Selwyn Proposed District Plan

Transport Feedback Review

Prepared for: Selwyn District Council
Job Number: SDC-J044
Issue Date: 3 September 2021
Prepared by: Shane Ingley, Senior Transportation Engineer
Reviewed by: Ann-Marie Head, Associate Director

Figure 3.1 Flow chart of the mechanism of ITA requirements

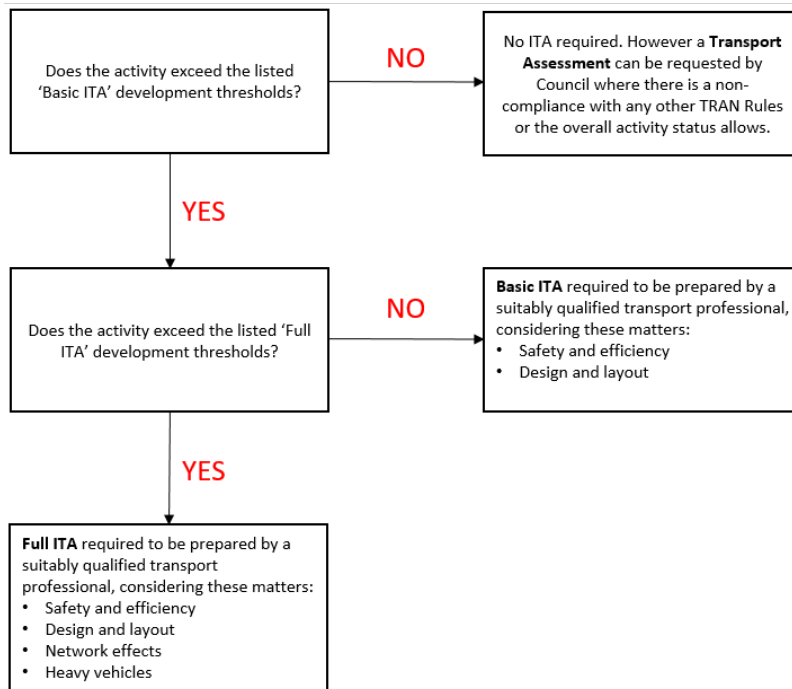
Proposed District Plan Text	Abley comments
<p>TRAN-P3</p> <p>Require Integrated Transport Assessments to assess the effects of high trip generating activities on the surrounding land transport network to:</p> <ol style="list-style-type: none"> 1. Maintain the safety and efficiency of land transport infrastructure by ensuring there is sufficient capacity in land transport corridors, including by integrating development with funded improvements to the network and ensuring the timing aligns with capacity; and 2. Establish whether the high trip generating activity can be supported by active transport modes, including accessibility to safe and convenient walking and cycling connections and access to public transport and public transport facilities. 	<p>The level of detail is appropriate for the Policy but could be expanded upon to include a note stating what an Integrated Transport Assessment is rather than assuming all readers will have an existing understanding.</p> <p>This note could state <i>“An Integrated Transport Assessment (ITA) is a report prepared by a suitably qualified transport professional; the matters to be included in an ITA are outlined further in TRAN-R8”</i></p>

<p>TRAN-R8</p> <p>Activity Status: PER</p> <ol style="list-style-type: none"> 1. The establishment of a new, or expansion of an existing activity listed in TRAN-TABLE2. <p>Where:</p> <ol style="list-style-type: none"> a. The activity complies with the basic ITA threshold in TRAN-TABLE2. <p>Activity status where compliance not achieved:</p> <ol style="list-style-type: none"> 2. When compliance with any of TRAN-R8.1 is not achieved: RDIS <p>Matters for discretion:</p> <ol style="list-style-type: none"> 3. The exercise of discretion in relation to TRAN-R8.2 is restricted to the following matters where a Basic ITA is required in TRAN-TABLE2: <ol style="list-style-type: none"> a. TRAN-MAT8.1 Safety and efficiency b. TRAN-MAT8.2 Design and layout c. TRAN-MAT8.5 ITA requirements 4. The exercise of discretion in relation to TRAN-R8.2 is restricted to the following matters where a Full ITA is required in TRAN-TABLE2: <ol style="list-style-type: none"> a. TRAN-MAT8 High Trip Generating Activities <p>TRAN-TABLE2</p> <p><i>(outlines trip generation thresholds and corresponding Basic or Full ITA requirements)</i></p>	<ol style="list-style-type: none"> 1.a. The mechanics of the Rule appear to be correct but are a little difficult to read as it is unclear what it means to ‘comply with’ the ITA thresholds. It could be clarified that ‘comply with’ means ‘does not exceed’. 3. The rule again appears to be correct; we suggest improving readability where possible while maintaining the intent. We suggest the following or similar wording: <i>“Where the Basic ITA threshold (but not the Full ITA threshold) in TRAN-TABLE2 is exceeded, the exercise of discretion in relation to TRAN-R8.2 is restricted to the following matters: ...”</i> And similarly for 4. <i>“Where the Full ITA threshold in TRAN-TABLE2 is exceeded, the exercise of discretion in relation to TRAN-R8.2 is restricted to the following matters...”</i> <p>In order to clarify what is required in an ITA, we recommend including (either under P3 or R8, whichever is more appropriate) the flow diagram in Figure 3.1.</p>

It is recommended to make the following updates to clarify the function of TRAN-P3 (and by association TRAN-R8):

- Include a note in TRAN-P3 to define what an ITA is, to the effect of: “An *Integrated Transport Assessment (ITA)* is a report prepared by a suitably qualified transport professional; the matters to be included in an ITA are outlined further in TRAN-R8”
- To ensure it is clear that an activity *not exceeding* the trip generation thresholds complies, we suggest replacing text in TRAN-R8 to the effect of ‘complies with ITA threshold’ with ‘does not exceed ITA threshold’. These instances are outlined in **Table 3.2** above.
- Include a flowchart as per **Figure 3.1** to illustrate how the ITA requirements apply and how these flow through to the matters of discretion.

Figure 5.2 Recommended amendment to DIAGRAM3

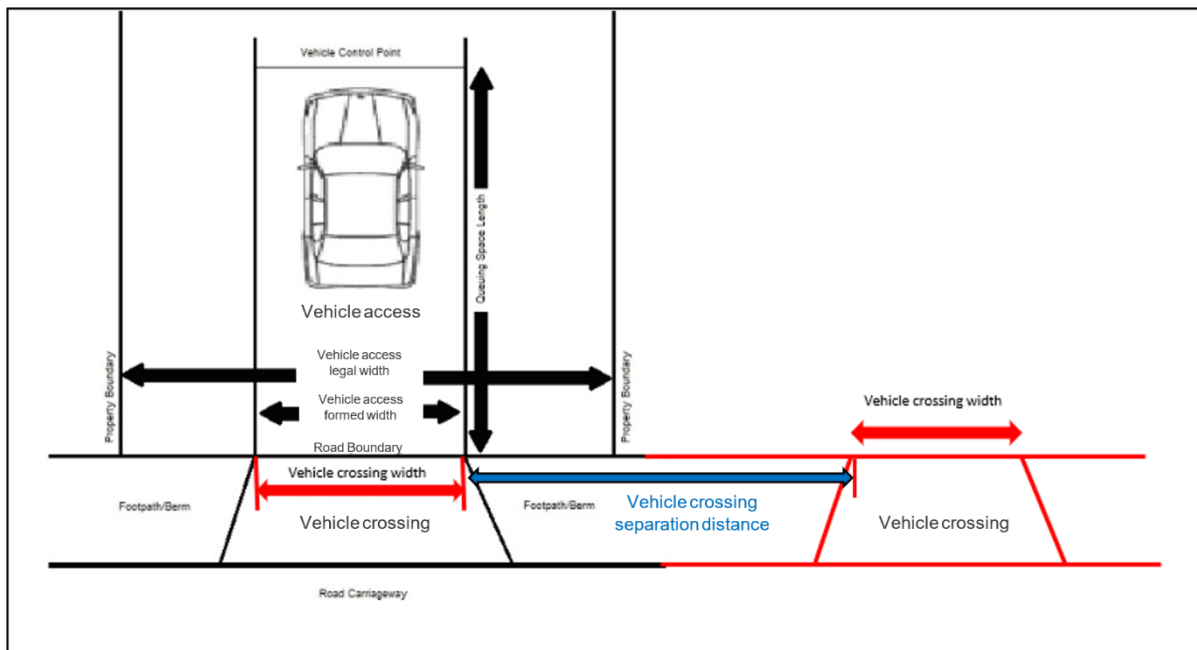
During our review we have noticed that DIAGRAM3 (Vehicle Crossing Widths) indicates that the vehicle crossing separation distance is to be measured at the kerb. A preferred approach is to measure at the property boundary as this is more practical and easier to control for developers and better reflects the purpose of the rule which is to ensure that vehicle crossings are adequately spaced on high-speed roads to minimise conflicting vehicle movements. We recommend updating DIAGRAM3 to show the measurement as indicated in **Figure 5.2**.

- Remove TRAN-DIAGRAM4 from the Plan and refer to specific updated diagrams and tables as appropriate as per the recommendations below.
- Replace TRAN-DIAGRAM3 with a similar diagram showing distances between vehicle crossings as measured at the site boundary rather than the kerbline, as per **Figure 5.2**.

Figure 5.4 Christchurch District Plan Figure 16 - Minimum distance of vehicle crossings from intersections outside the Central City

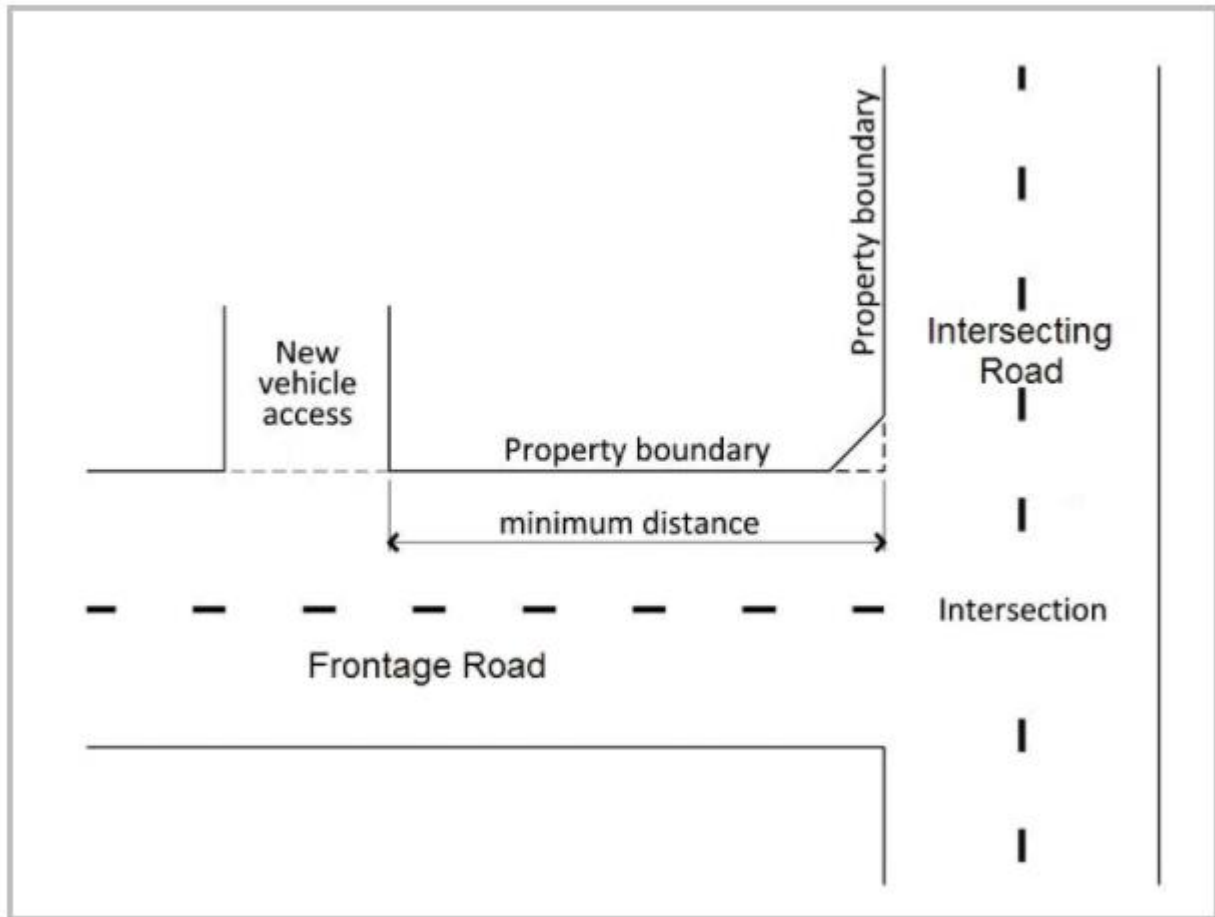
A preferred approach is to measure this distance from the property boundary as this takes into account the possibility of future road widening which may change the kerbline. This approach is consistent with that used in Auckland and Christchurch to measure distances from intersections to vehicle crossings. To ensure consistency with the way these distances are measured, we recommend:

- Replacing DIAGRAM1 with a new diagram showing the minimum distance as measured from the property boundary rather than the kerbline. This could be as per Figure 16 from the Christchurch District Plan, included as **Figure 5.4** below.

- Replace DIAGRAM1 with a similar diagram showing that the distance between a vehicle crossing and an intersection shall be measured from the property boundary rather than the kerbline, as per **Figure 5.4**.
